7. CASE 23.134, 572 ELMWOOD AVENUE, John Howe/Joseph Metcalf House, 1858-62, 1867 (SOUTH ELMWOOD

Proposal: The scope of work proposed consists of Major Alterations and includes:

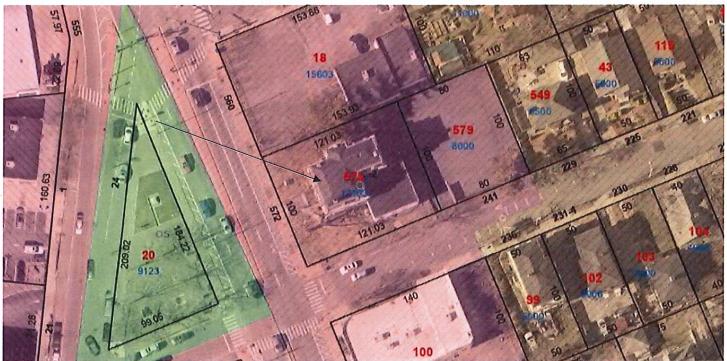
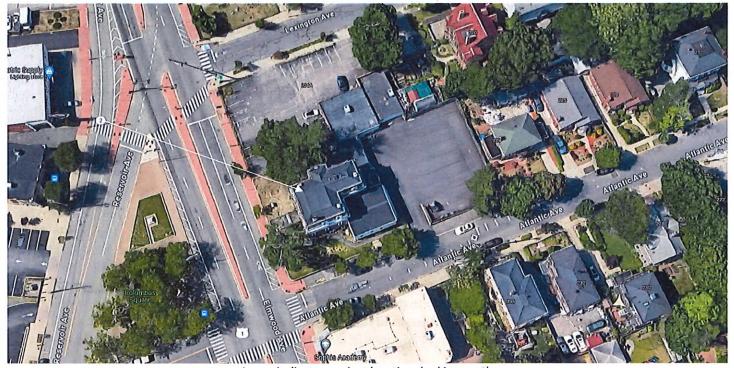
the replacement of the existing mansard slate roof with an architectural shingle roof.

- The applicant contacted staff about the need to replace the slate roof. Staff directed the applicant to have a slate roof specialist evaluate the roof. The applicant had HMR Construction Inc (T.D. Dumas) conduct a site visit and evaluate the roof. A quote verifying that the roof is a Vermont grey slate that is now defoliating and is past it's usable life cycle. HMR recommends removal and estimates a new slate roof to be approximately \$71,300. There are three proposals for the replacement asphalt-shingle roof:
 - 1. Certainteed Carriage House;
 - 2. Certainteed Grand Manor; and,
 - 3. GAF Royal Sovereign approximately \$19,000 (ASAP Roofing).

Staff recommends Option 3 in a Nickel Gray color;

- The property was acquired with Federal dollars (CDBG) and this scope-of-work is also being reviewed by the RI
 Historical Preservation & Heritage Commission;
- The proposed modifications will be visible from the public rights-of-ways; and,
- Quotes from HMR Construction Inc, ASAP Roofing and GAF brochure sample have been submitted.

Staff recommends a motion be made stating that: The application is considered complete. 572 Elmwood Avenue is a structure of historical and architectural significance that contribute to the significance of the South Elmwood local historic district, having been recognized as a contributing structure to the Elmwood National Register Historic District. The Commission grants Final Approval of the proposal as submitted having determined that the proposed alterations are appropriate as the proposed alterations are architecturally and historically compatible with the property and district having an appropriate size, scale and form that while diminishing the historic character of, will not have an adverse effect on the property or district, as the proposed modifications are minimally-not visible from the public rights-of-ways, citing and agreeing to the recommendations in the staff report, with staff to review any additional required details.
